# UNITED STATES PATENT AND TRADEMARK OFFICE

APPLICATION NO.	FILING DATE	FIRST NAMED INVENTOR	ATTORNEY DOCKET NO.	CONFIRMATION NO.
10/579,976	05/22/2006	Jong Chul Bang	9988.327.00	3738

<b>Office Action Summary</b>	<b>Application No.</b> 10/579,976	<b>Applicant(s)</b> BANG, JONG CHUL	
	<b>Examiner</b> JASON P. RIGGLEMAN	<b>Art Unit</b> 1711

## **DETAILED ACTION**

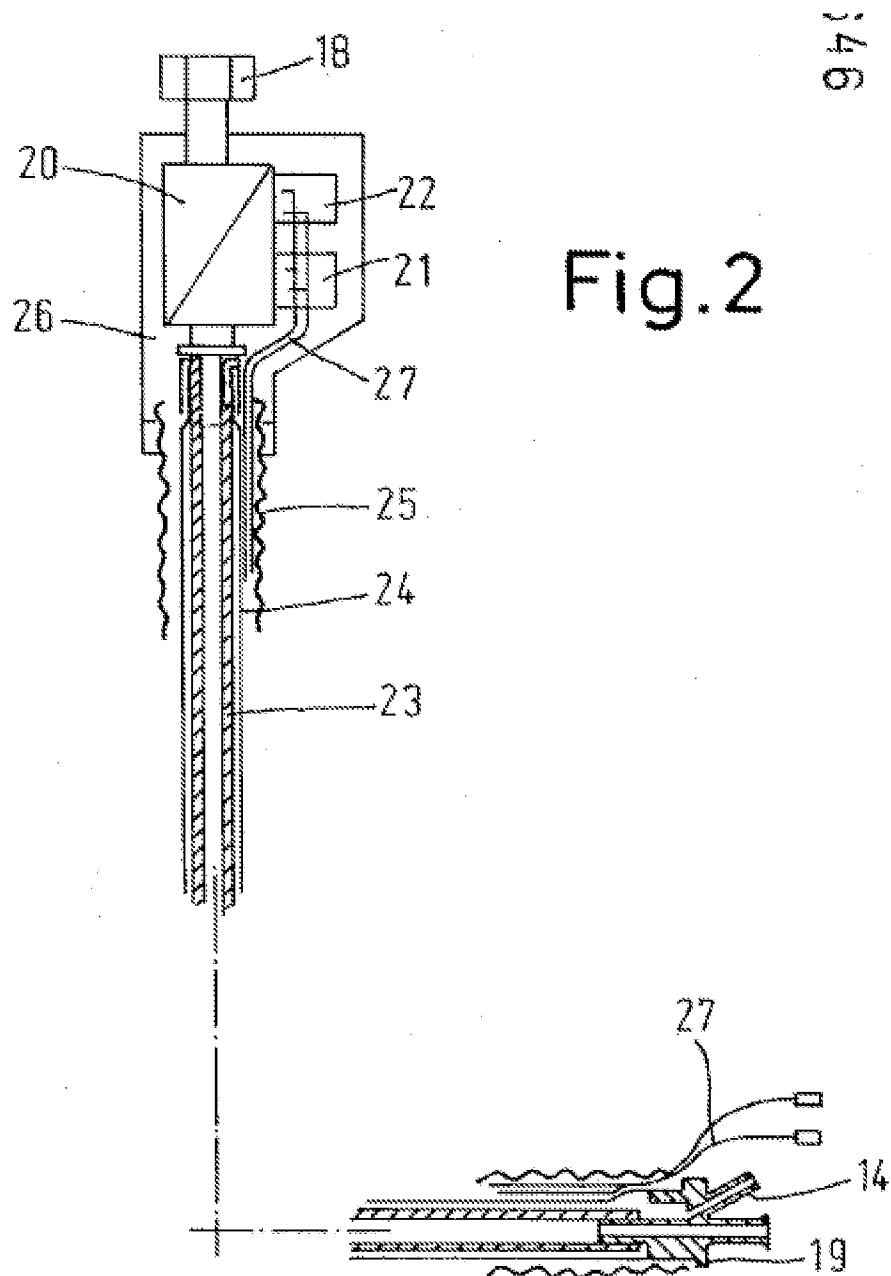
*12.* Claims 1-2, 5, 8-10, and 13 are rejected under 35 U.S.C. 103(a) as being unpatentable over Gumm et al. (EP Patent Publication No. EP0293031) in view of Sassone (German Patent Publication No. DE19650861).

*13.* Gumm et al. teaches an aqua stopping device for a washing device having a valve body including a passage (conduit 3A) formed within. Valves (21, 22) are aligned to open and close the passage. Signal wires (27) are connected to a terminal of the valves. A connecting tube (23) is attached to a lower portion of the valve body for passing wash water there through. An outer tube (24) is disposed around an exterior of the connecting tube for enclosing the connecting tube, see Fig. 2, inserted into text, below.

14. Gumm et al. does not teach the use of one wire splitting into two wires; however, it has been held that an obvious choice in design is not patentable (*In re Kuhle* 188 USPQ 7). It would have been obvious to use one wire (27) to conserve materials – electrical wire. Obviously, the closer to the solenoid terminals – the more wire is conserved. This introduces one problem;

however, which is preventing liquid from contacting the wires. Once again, it is well known by Sassone to use injection molded plastic “filler” to insulate and waterproof the electrical split. Utilizing the minimum of needed “filler” would place it at the split area only. It would have been obvi

15. This leads to the inventive feature of the applicant’s -- inner case. Gumm et al. as modified by Sassone et al. does not teach an inner case; however, the applicant has not established any criticality to the feature. It appears to be an artifact from the manufacturing process used to install the filler and is not relevant in the final product. The combination of Gumm as modified by Sassone, as modified above, appears to function in the same way as the claimed invention and no criticality has been demonstrated by the applicant's design. The applicant has shown no criticality for this design feature. Further, the “inner case” of the invention is merely a wall which forms a volume acting as a mold for the injection molding of the filler. The “filler” need not be injected but merely present to encapsulate the electrical wire.
